UNITED STATES PATENT AND TRADEMARK OFFICE

APPLICATION NO.	FILING DATE	FIRST NAMED INVENTOR	ATTORNEY DOCKET NO.	CONFIRMATION NO.
10/751,092	01/02/2004	William R. Dodds	3158.01US02	1330

Office Action Summary	Application No. 10/751,092	Applicant(s) DODDS, WILLIAM R.	
	Examiner Trinh T Nguyen	Art Unit 3644

DETAILED ACTION

3,205,860

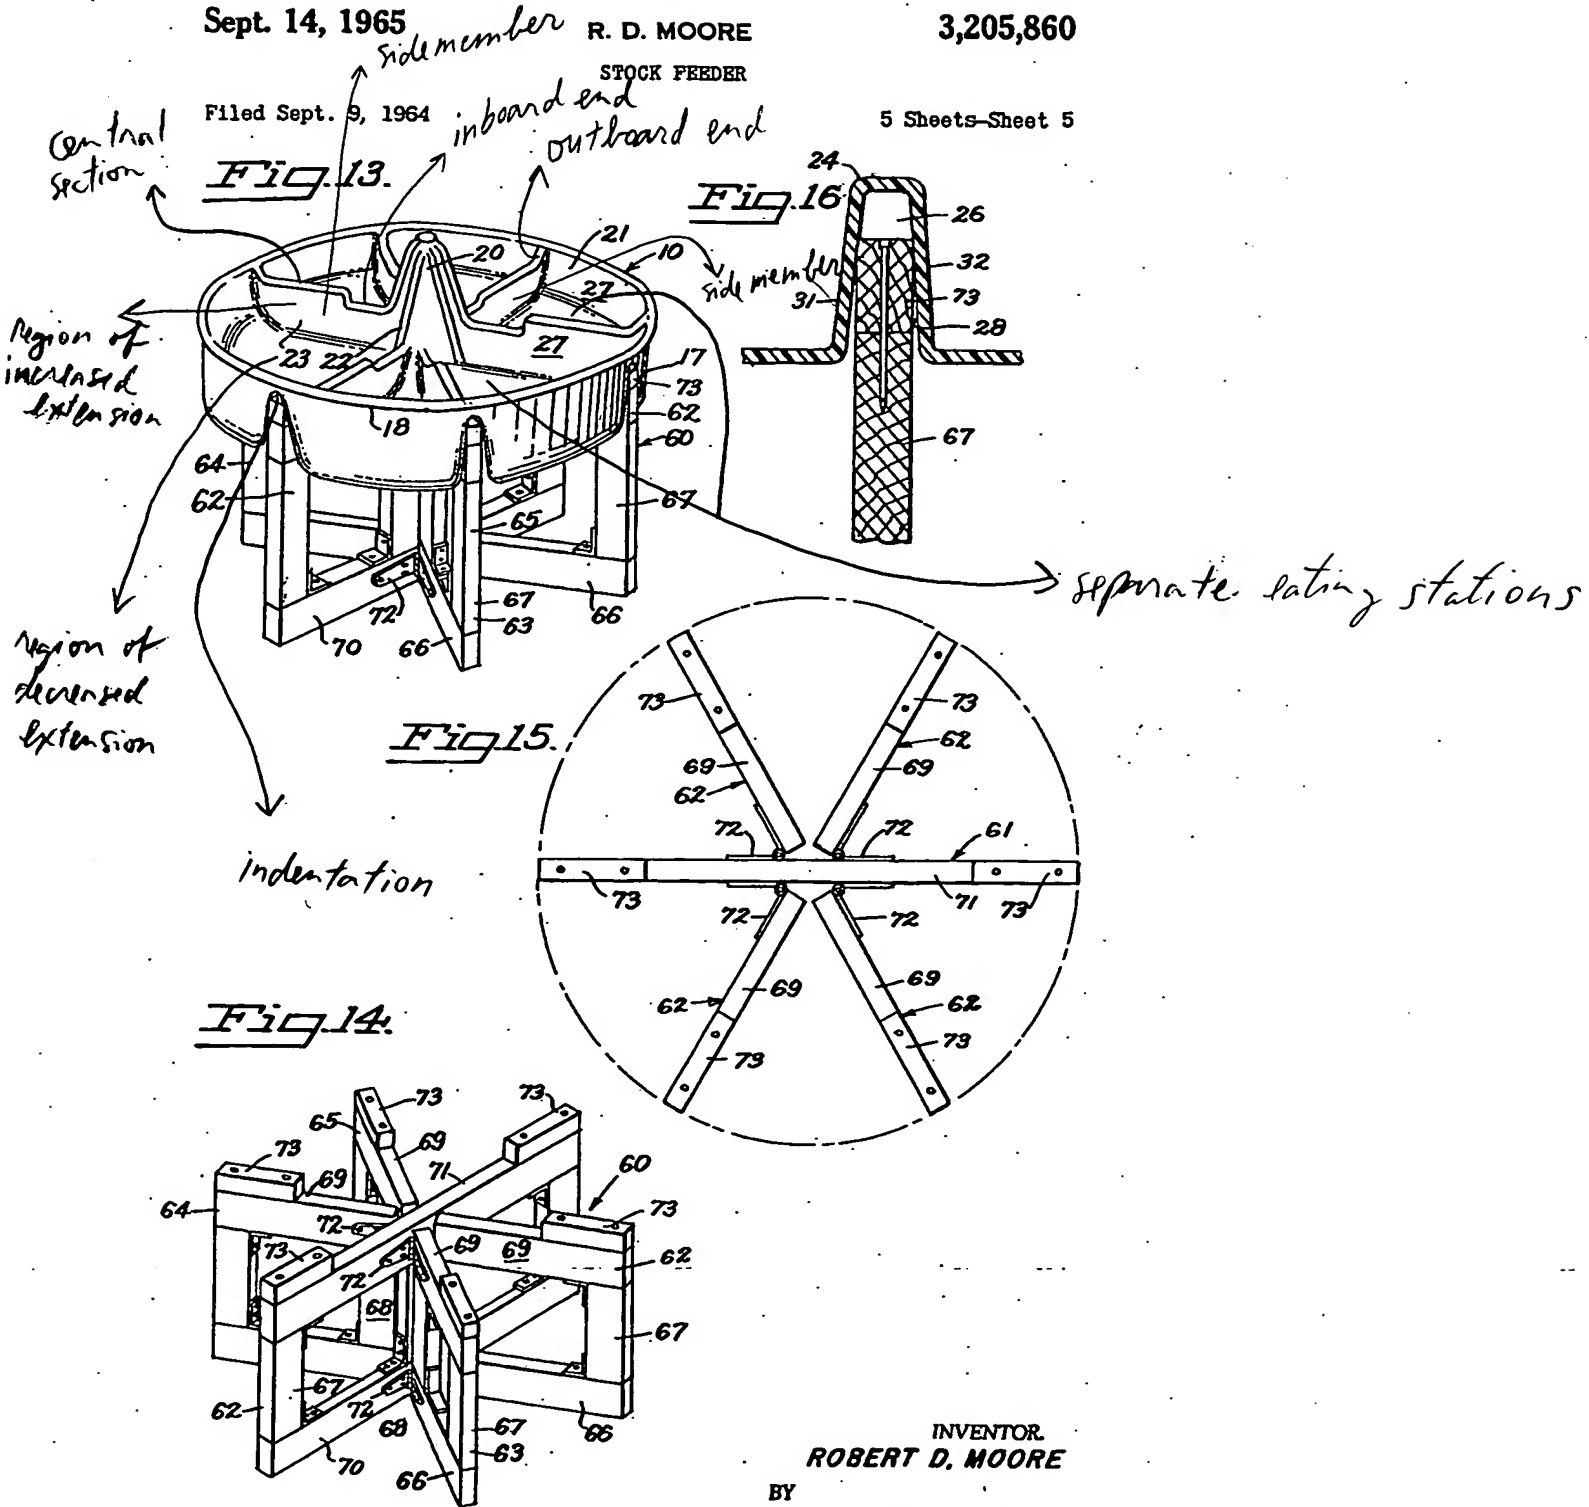
3. Claims 1-6, 8-12, 15-17, 23, and 26 are rejected under 35 U.S.C. 103(a) as being unpatentable over Moore (US 3,205,860) in view of Struckhoff (US 3,004,518) (please see a more detail Figure 13 of Moore attached with the Office Action for further explanation for the rejections of claims -6, 8-12, 15-17, 23, and 26).

Moore discloses a feeding apparatus comprising a container (11, 12, 13) having a plurality of side walls; and an undulating extension surrounding the container having regions of increased extension and regions of decreased extension, wherein the undulating extension defines a plurality of separate eating stations, wherein the regions of increased extension comprise an outboard end and an inboard end, and wherein the inboard end is adjacent the container (see attached Figure 13 of Moore at the end of this Office Action for further explanation).

For claim 2, Moore as modified by Struckhoff (emphasis on Moore) further discloses the container further comprises a first section (11) connected to a second section (12).

For claim 6, Moore as modified by Struckhoff (emphasis on Moore) further discloses a feed divider member (20) located within the container.

For claim 8, Moore as modified by Struckhoff (emphasis on Moore) further discloses the outboard end is positioned higher than the inboard end.

For claim 10, Moore as modified by Struckhoff (emphasis on Moore) further discloses the regions of increased extension further comprise an indentation located near the outboard end.

For claim 11, Moore as modified by Struckhoff (emphasis on Moore) further discloses regions of increased extension can further comprise a central section that runs parallel to the ground.

For claim 12, Moore as modified by Struckhoff (emphasis on Moore) further discloses the central section has a pair of side members that slope to form a trough-like shape.

For claim 15, Moore as modified by Struckhoff (emphasis on Moore) further discloses the feeding device is supported by a truss system (69).

For claim 16, Moore as modified by Struckhoff (emphasis on Moore) further discloses a plurality of support legs (67) are attached to the truss system to support the feeding apparatus.

For claim 17, Moore as modified by Struckhoff (emphasis on Moore) further discloses each of the plurality of support legs are connected to a base portion (66).
